This manuscript compares three different techniques to track bedforms and estimate bedload transport rates. This paper could be very useful for scientists who consider estimating bedload transport rates by bedform tracking, even though the paper does not include new methods. In general, the introduction, discussion and conclusion are very clear and informative. However, the methods and results are sometimes more difficult to read and need extra sentences to explain the concepts and how the conclusions are derived from the results. See my comments below.

Fig. 1. Dimensions of a triangular sand dune

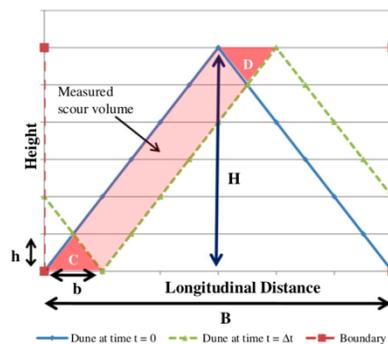
- Section 2.3, L28: what is the physical meaning of q_e and why does it need to be added? Could you add a short explanation?

Q_e represents an area of underpredicted transport discussed by Shelley et al. (2013). The area represented by C in Shelley et al. (2013) figure 1 (see below) is not accounted for using the original method of Simons et al. (1965). q_e is the area of triangle D and therefore accounts for that missing portion. We have added a short explanation of q_e to the text. It is a very small contribution to total computed flux.
